PIA Technical Bulletin TB-301

Parachute Industry Association Publications March 02, 2000

Container Grommets and Small Suspension Lines

Figure 1 -
Suspension-line snagged around improperly seated container flap grommet.

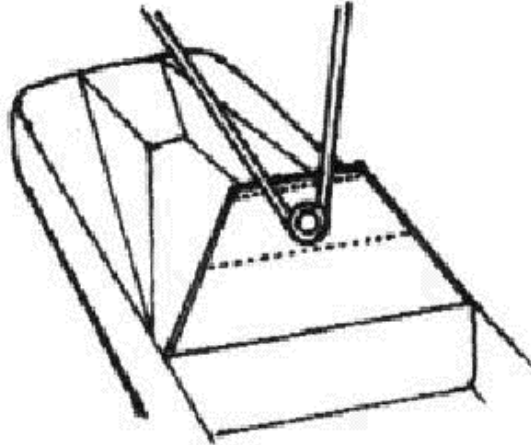
Because of two recent fatalities involving relatively small suspension lines snagging on container grommets, as well as other similar incidents not resulting in fatalities, the PIA Technical Committee recommends:

1) All container grommets should be inspected to ensure that they are properly set See figure 1.

Figure 2
Suspension line snagged around grommet on main loop anchor

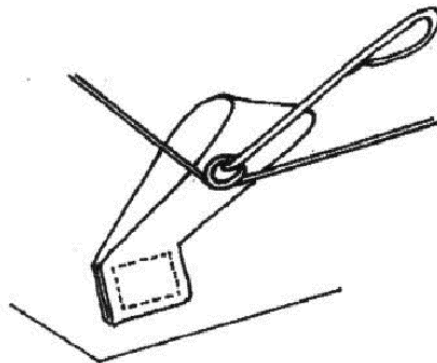
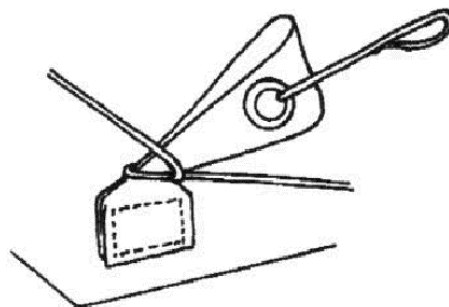
2) On main containers with a "main closing loop webbing anchor", users / riggers should contact the manufacturer for their current recommendations. See Figures 2 and 3.

3) Because of design specific issues, PIA further requests that all equipment manufacturers individually address these issues and disseminate relevant information to the field.
